Santa Ana River Wasteload Allocation Model Update

BASIN MONITORING PROGRAM TASK FORCE

Updated Responses to Comments on Draft TM No. 3

Summary of Comments for Draft TM No. 3 - WLAM Predictive Scenario Runs (30-Oct-18 Task Force Meeting)

Comments on Draft TM No. 3 from OCWD – Comment No. 8

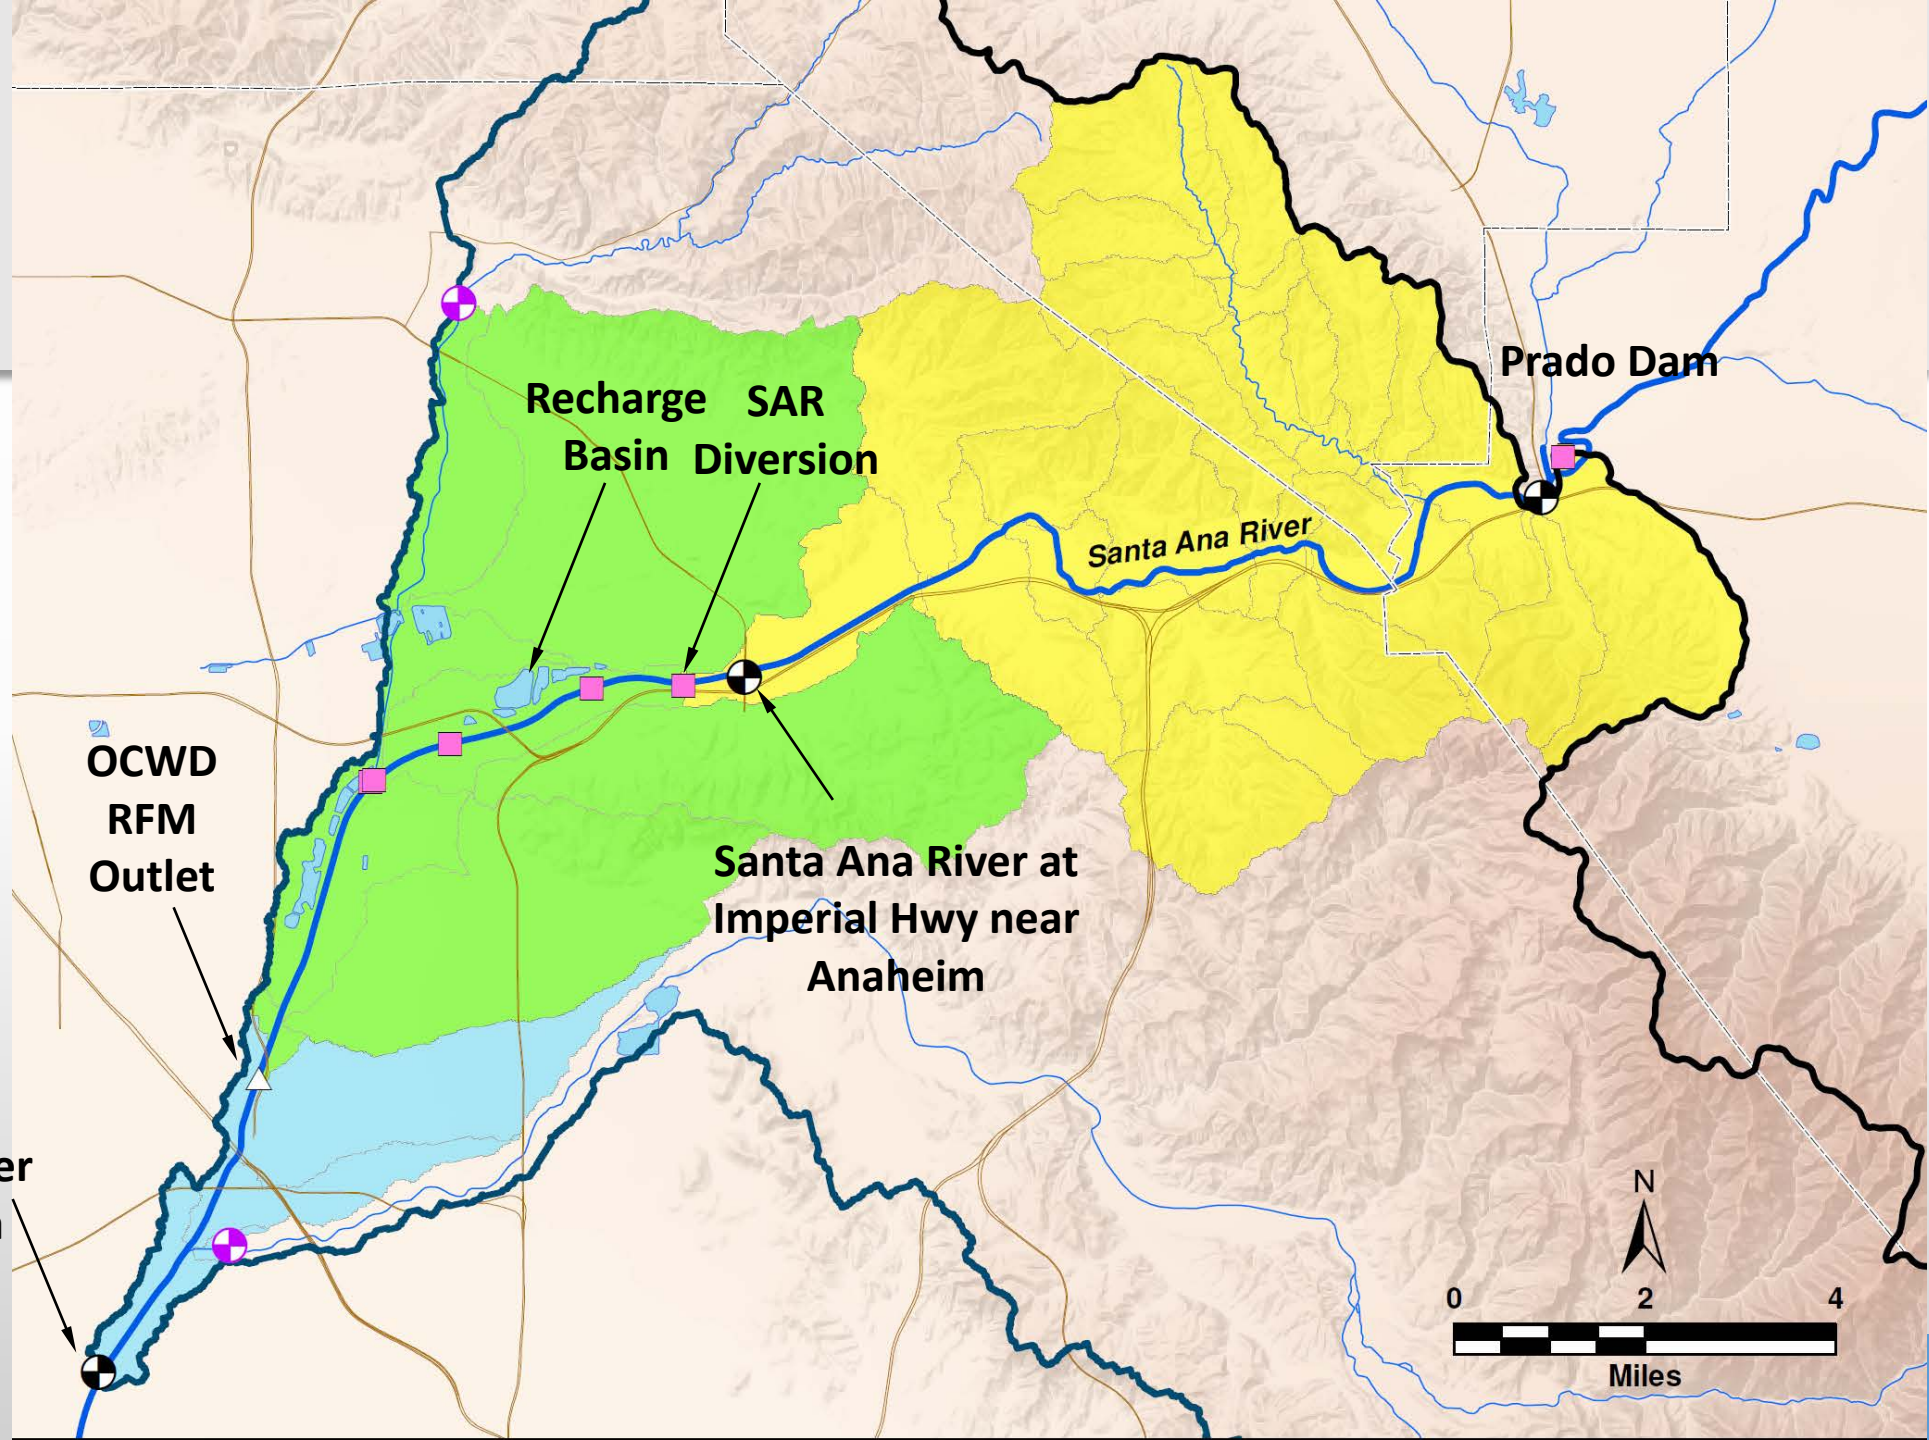
No.	Section	Pg.	Comment	GEOSCIENCE Response
8	3.1.7	22	The draft memo says “The Basin Plan Amendment to adopt the Salt and Nutrient Management Plan for the Upper Temescal Valley GMZ is expected to be approved by 2020. Nevertheless, the 2017 WLAM HSPF was used to evaluate the impact and the compliance of streamflow and groundwater recharge with the proposed TDS and TIN.” The Task Force should discuss if this is acceptable; it may be necessary to evaluate the WLA model results with the adopted water quality objectives and the proposed objectives.	The Upper Temescal Valley GMZ represents a new GMZ that has no current water quality objectives . Therefore, the proposed objectives will continue to be used per the suggestion of the Regional Board and Task Force.
